Re: Florida Power & Light Company
Proposed Turkey Point Units 6 and 7
Docket Nos. 52-040 and 52-041
Response to NRC Request for Additional Information Letter No. 037
(eRAI 5896) SRP Section - 02.05.02 Vibratory Ground Motion

FPL Response to NRC RAI No. 02.05.02-2 (eRAI 5896)

NRC RAI Number: 02.05.02-2 (eRAI 5896)

Re: Florida Power & Light Company
Proposed Turkey Point Units 6 and 7
Docket Nos. 52-040 and 52-041
Response and Response Schedule to NRC Request for Additional Information
Letter No. 037 (eRAI 5896) SRP Section - 02.05.02 Vibratory Ground Motion

Figure 3c. EPRI (FSAR Reference 242) Mid Continent 10Hz weighted mean attenuation curve for a magnitude 8 earthquake.

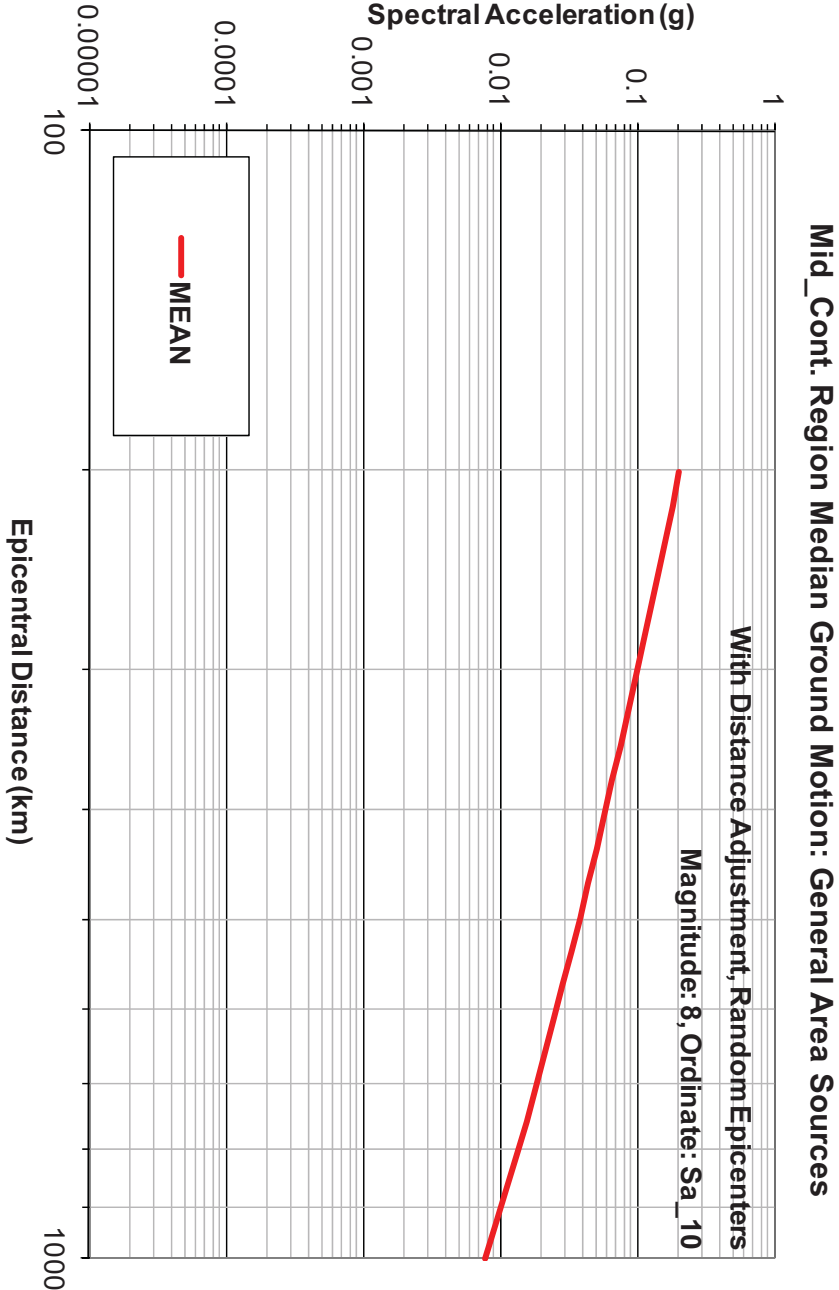
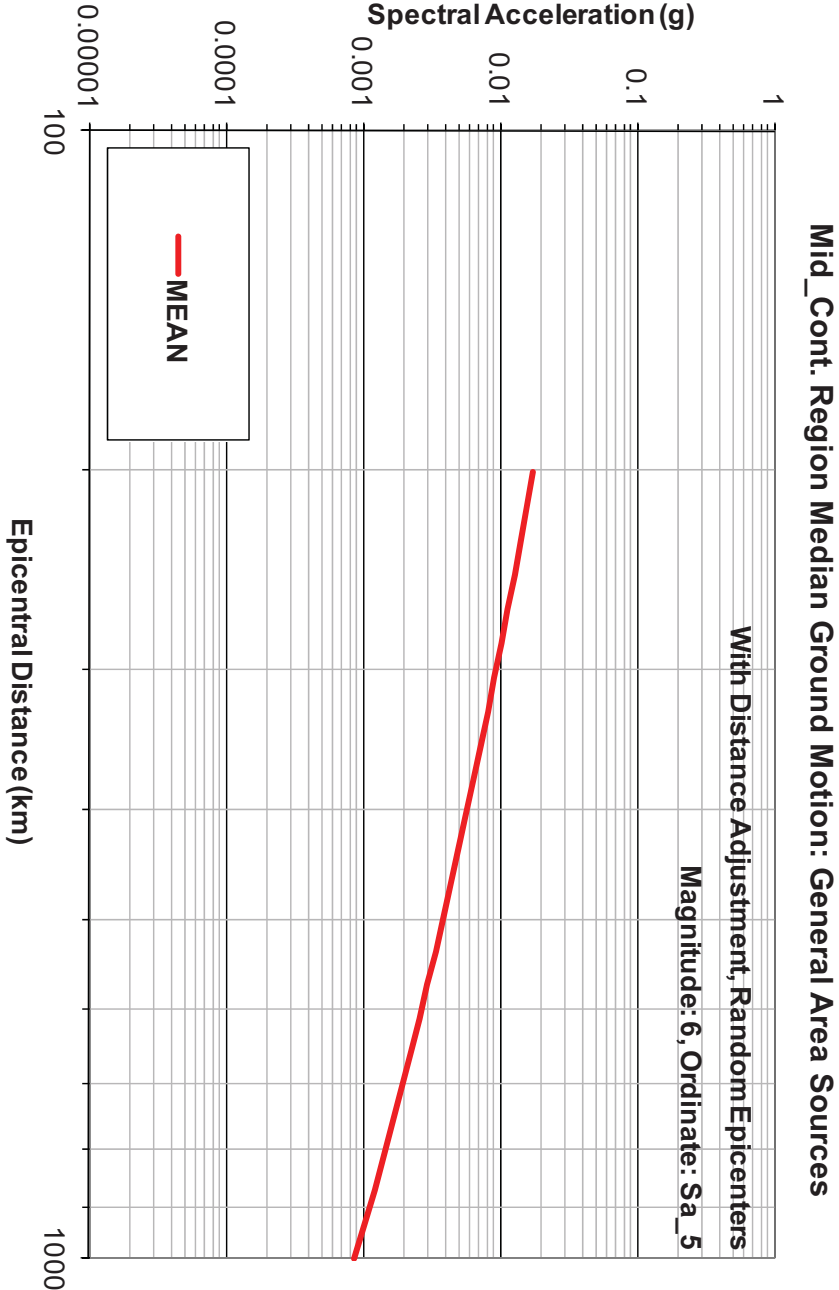
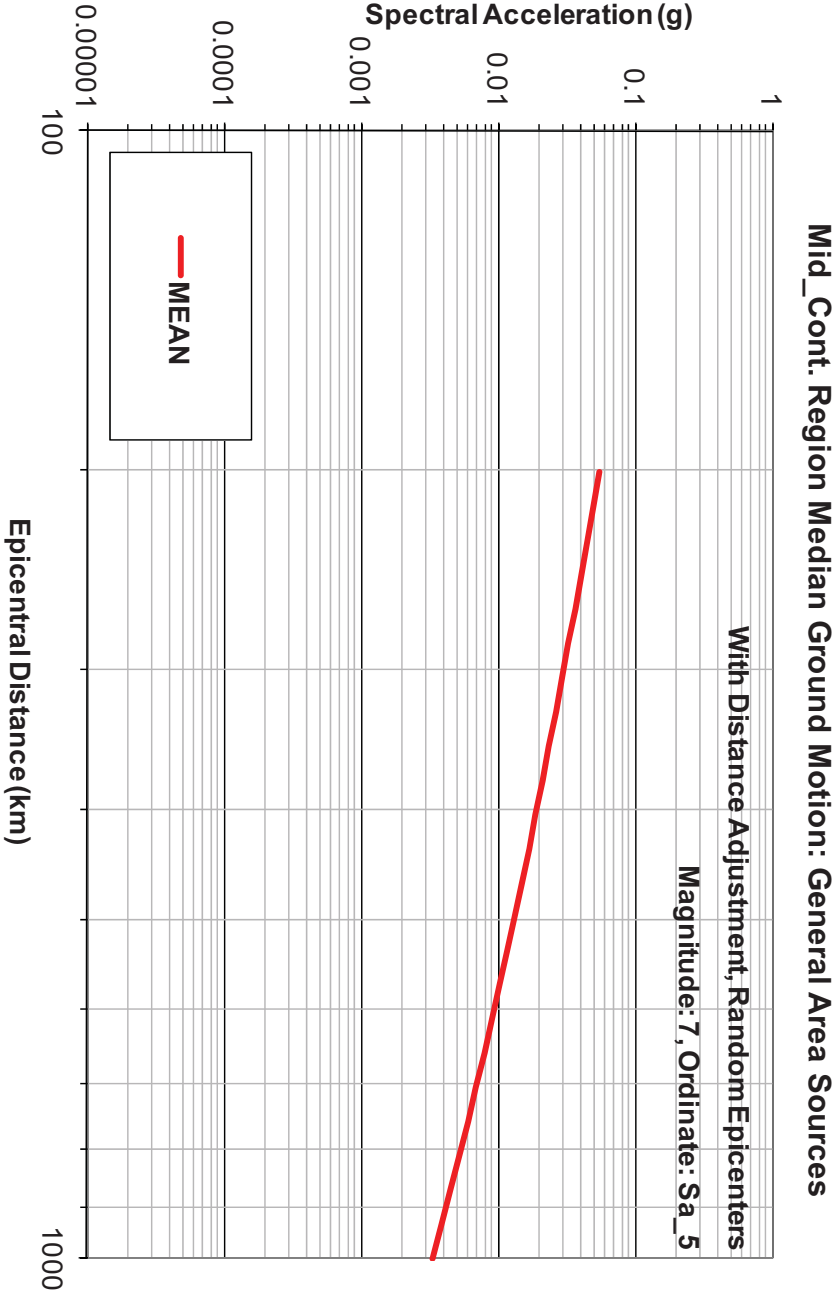
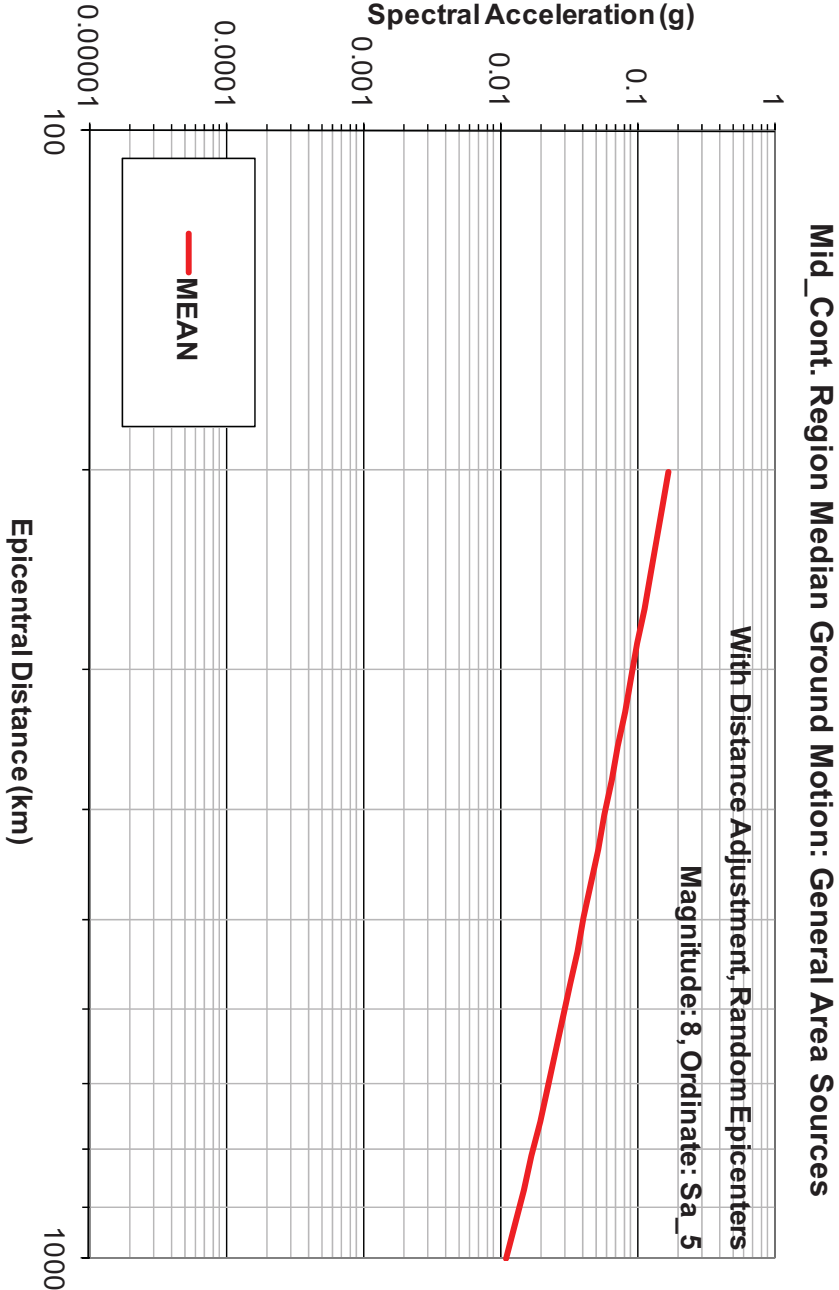
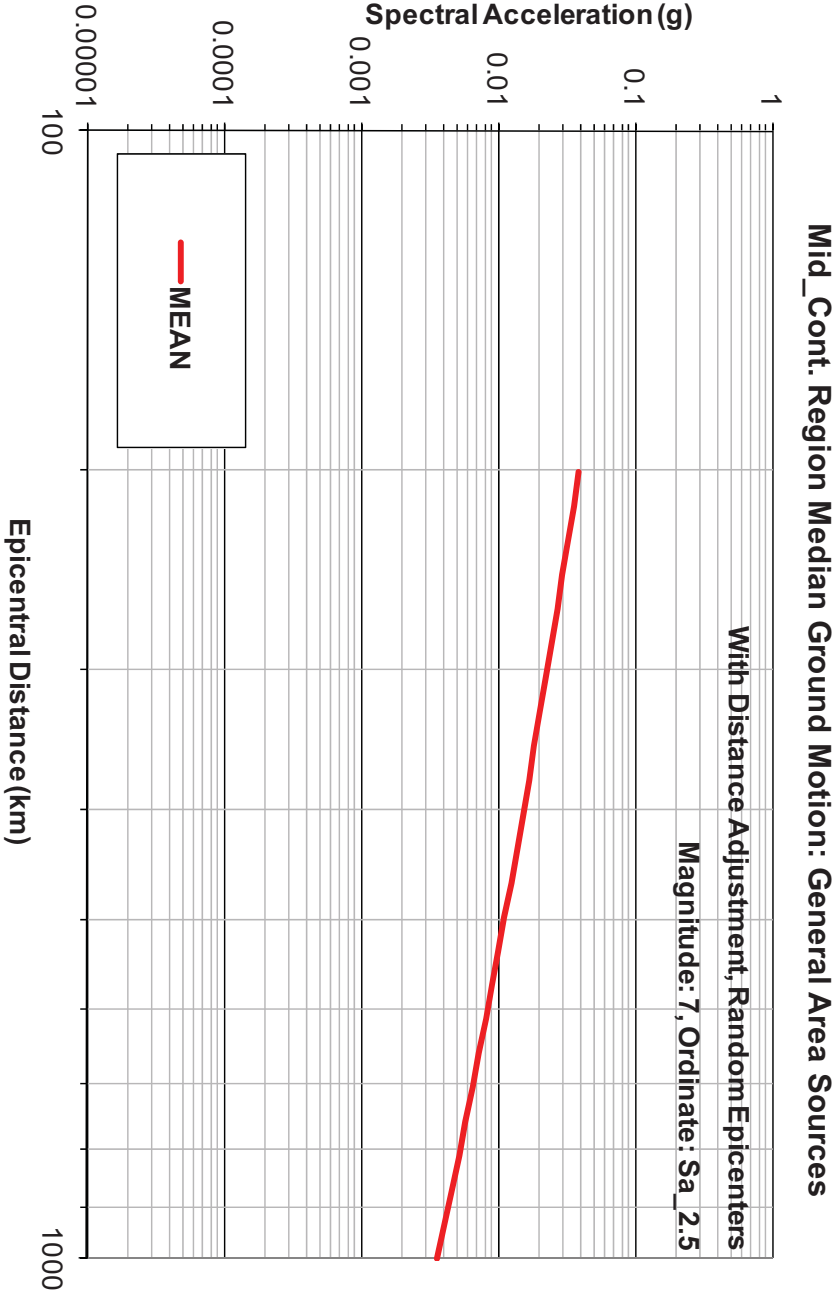
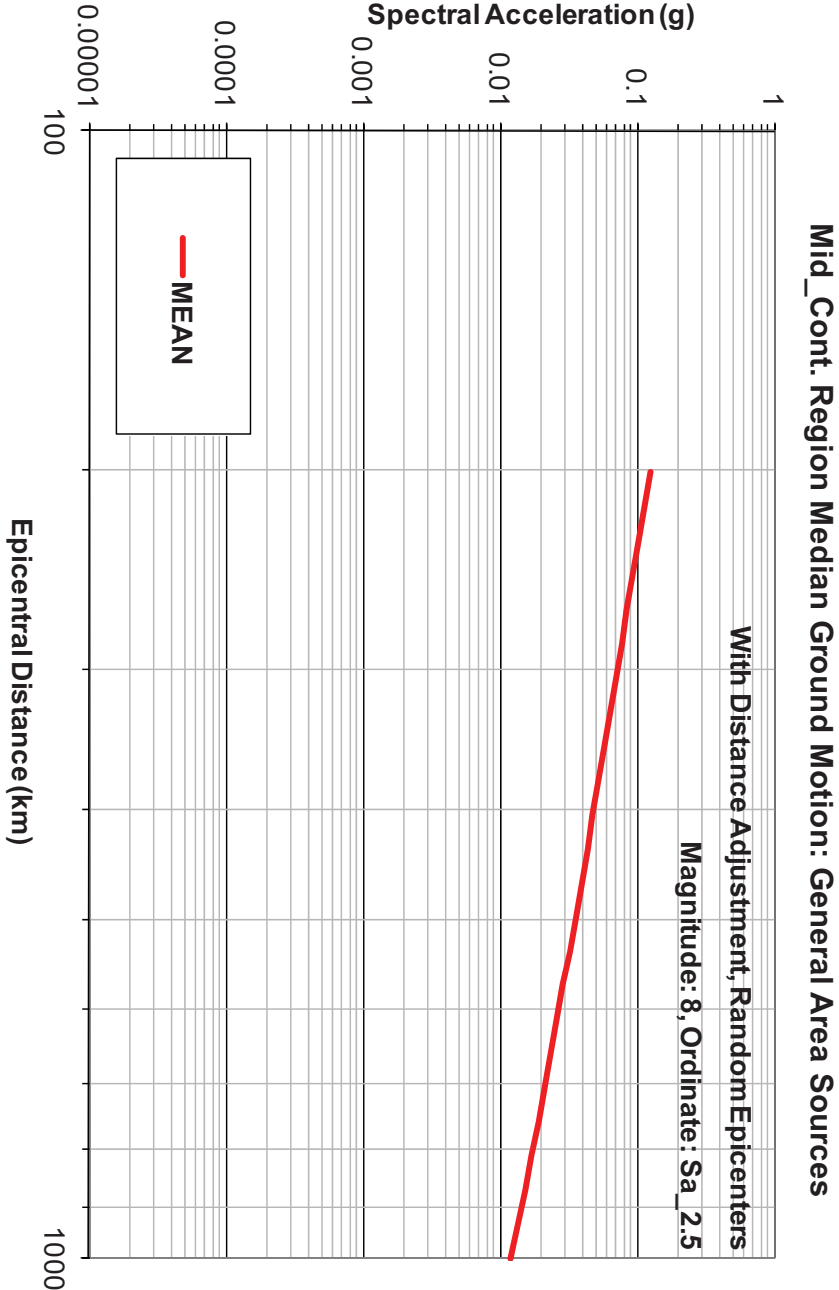
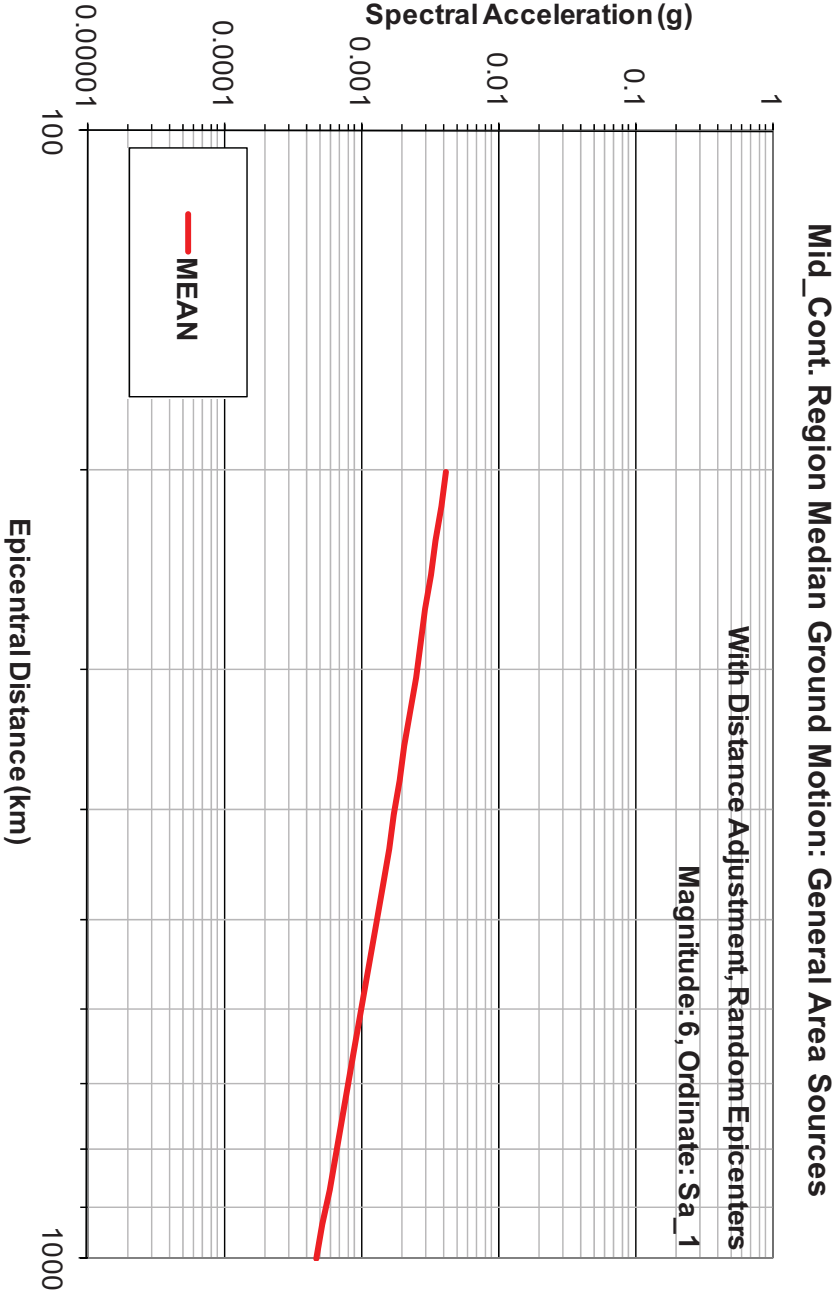
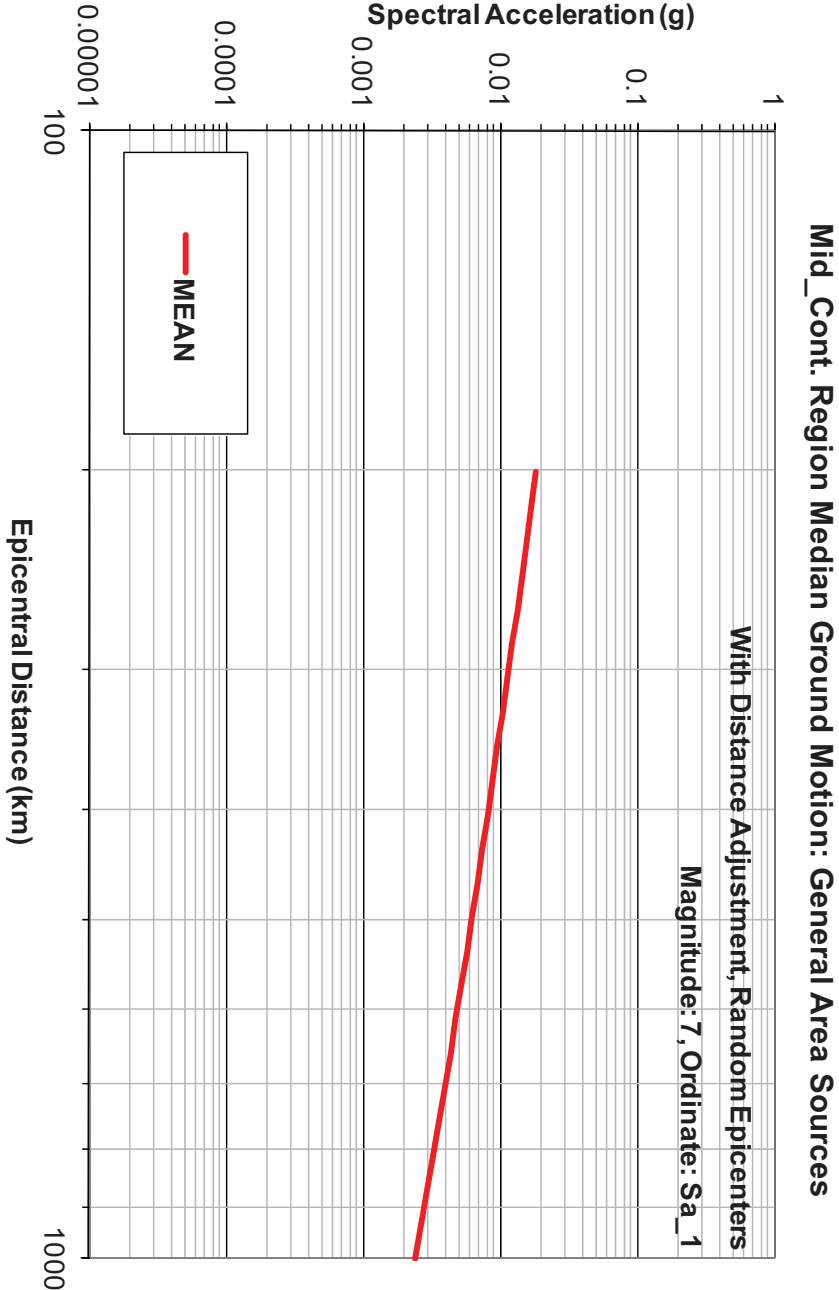
- d. In order for the staff to be able to compare the new Caribbean GMPEs with the 2004/2006 EPRI mid-continent GMPEs, please provide plots showing both ground motion models for earthquake magnitudes of 6.0, 7.0, and 8.0 in the distance range of 200 km to 1000 km at all seven frequencies defined in the EPRI 2004 and 2006 GMPEs.

Ground motion attenuation curve plots are provided for the EPRI (FSAR References 242 and 203) and Caribbean ground motion prediction equations (GMPEs). Note that EPRI (FSAR Reference 203) is only a recommendation for the associated aleatory uncertainty and therefore does not impact the comparison plots of the weighted mean ground motion

attenuation curve. The plotted mean attenuation curve is the weighted mean of the individual median attenuation curves as defined in EPRI (FSAR Reference 242). These attenuation plots are provided for three specific moment magnitude (M_w) values: 6, 7, and 8 for distances between 200 km and 1,000 km. Note that the EPRI (FSAR Reference 242) ground motion attenuation model is defined as a function of epicentral distance, whereas the Caribbean ground motion attenuation model is defined as a function of hypocentral distance. However, because the closest distance is 200 km, the difference between the epicentral and hypocentral distances would be less than 1% for a typical crustal depth of 10 km and even smaller for larger distances out to 1,000 km.

The weighted mean ground motion attenuation curves for the EPRI (FSAR Reference 242) model are given in Figures 1 through 7 for the three magnitudes and seven spectral frequencies requested in the RAI. The weighted mean Caribbean ground motion attenuation curve plots for the same suite of magnitudes, distances, and spectral frequencies are shown in Figures 8 through 14.
